**CITY OF TEMPE
DEVELOPMENT REVIEW COMMISSION**

Meeting Date: 10/27/2015
Agenda Item: 5

ACTION: Request for a Development Plan Review consisting of 27,485 square-feet of building additions for TEMPE KIA (PL150374), located at 8005 South Autoplex Loop. The applicant is John Mahoney Architects, LLC.

EXT ELEVS SERV & CARWASH

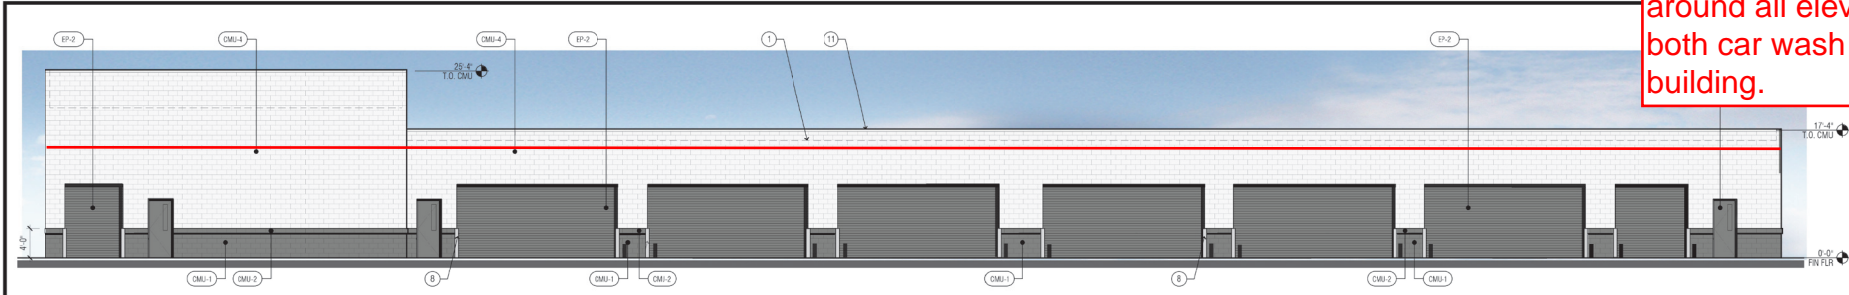
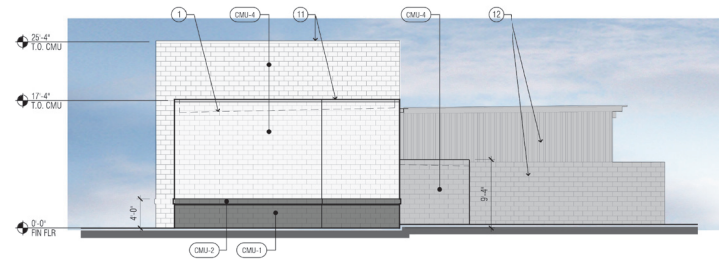
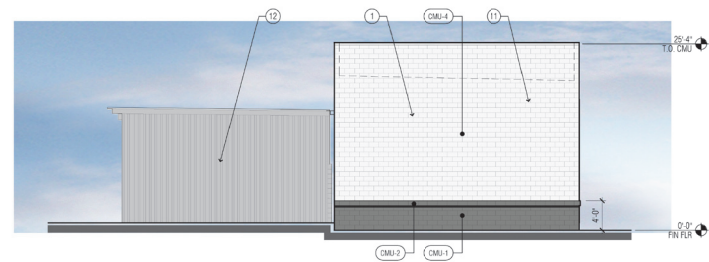
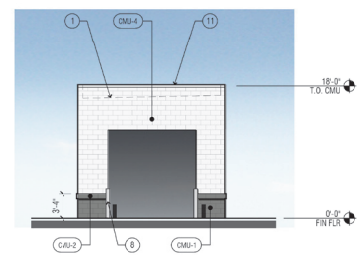
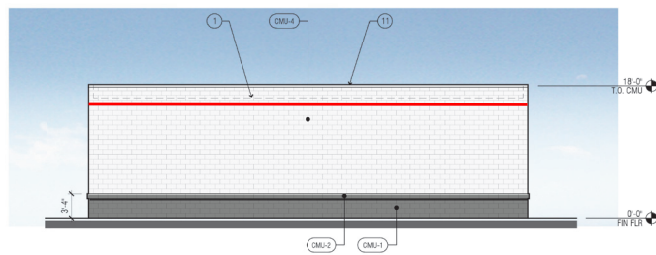
The proposed car wash and service buildings will be conditioned to paint the upper portion of elevations Benjamin Moore – Charcoal Gray, to create a defined top of building. A redlined elevation is attached to demonstrate this condition.

Paint Benjamin Moore - Charcoal Slate, above red line. Paint band shall wrap around all elevations for for both car wash and service building.

9. Top portions of car wash and service building shall be painted Benjamin Moore, Charcoal Gray.
10. Provide secure roof access from the interior of the building. Do not expose roof access to public view.
11. Conceal roof drainage system within the interior of the building.
12. Incorporate lighting, address signs, and incidental equipment attachments (alarm klaxons, security cameras, etc.) where exposed into the design of the building elevations. Exposed conduit, piping, or related materials is not permitted.
13. Locate the electrical service entrance section (S.E.S.) inside the building or inside a secure yard that is concealed from public view.
14. Upper/lower divided glazing panels in exterior windows at grade level, where lower glass panes are part of a divided pane glass curtain-wall system, shall be permitted only if laminated glazing at these locations is provided.
